Design Review Subcommittee (DRSC)

Meeting Date: May 24, 2017

SUBJECT: **Minor Cultural Heritage Permit (MCHP) 16-372, Pacific Building Patio**
a request for exterior changes to include minor repair and paint and construct an outdoor patio at the rear of the building located at 120 South El Camino Real. The project is located in the Mixed Use Zoning District, and in the Architectural and Central Business Overlays (MU 3.0-CB-A).

Figure 1 – Friends of the Library Wrought Iron Illustration

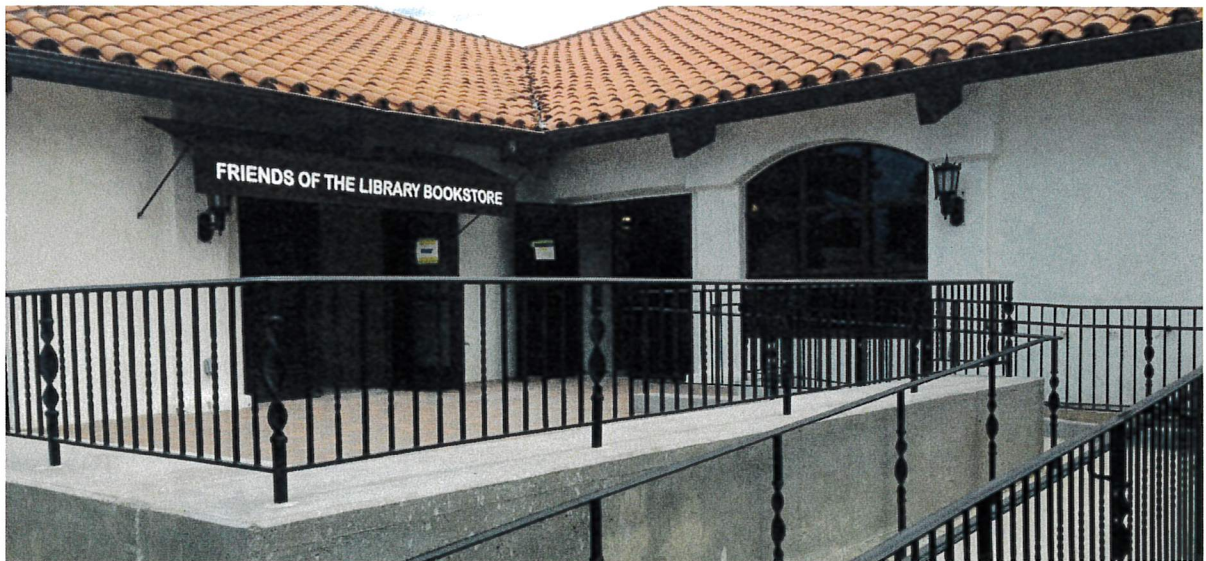
Recommendation:	Applicant Response:
2. Metal hand rail should not be two inch by two inch metal. Metal rail should be solid wrought iron to match traditional look.	No response provided.

1. Revise the metal hand rail to a more traditional look. Staff recommends the applicant match the wrought iron detail used at the library in front of the “Friends of the Library”. Refer to Figure 1 below:
